UNITED STATES PATENT AND TRADEMARK OFFICE

Office Action Summary

10/590,581

DETAILED ACTION

Claims 1-5, 8-10, 15, 22-24 and 26 are rejected under 35 U.S.C. 102(b) as being anticipated by Gramnas (6,302,918).

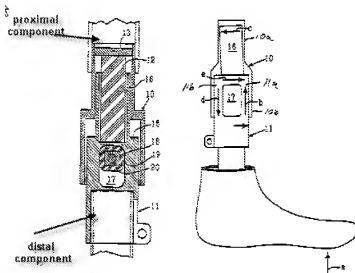
Gramnas teaches an apparatus fully capable of attaching prosthetic limb to a bone.

Said apparatus comprising a proximal component and a distal component moveably coupled via a coupling body including at least element 18 with respect to each other in at least axial rotation. The apparatus is in a fixed relationship at a first force level and upon a higher predetermined force which exceeds the resilient biasing mechanisms (elements 19 and 20), the proximal and distal component can rotate relatively.

At least claim 3, elements 18-20 are interpreted as be a "clutch-like mechanism".

Claims 5, 23, 24, regarding the "adjustment means", see 3:24 et seq. teaching resilient member 19 can be exchanged for another member.

Claim 22, elements 18-20 are interpreted as the "automatically disengageable connector".

FIG. 2

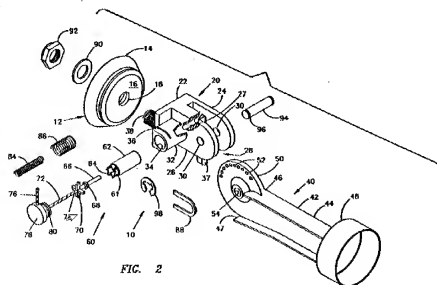
Weddendorf teaches an apparatus fully capable of attaching prosthetic limb to a bone.

Said apparatus comprising a proximal component and a distal component moveably coupled via a coupling body including at least elements 94, 54, 66 with respect to each other in at least axial rotation. Wherein a force placed on the proximal

and distal component higher than the shear strength of pin 66 the coupling body automatically disengages from a fixed angle relation.
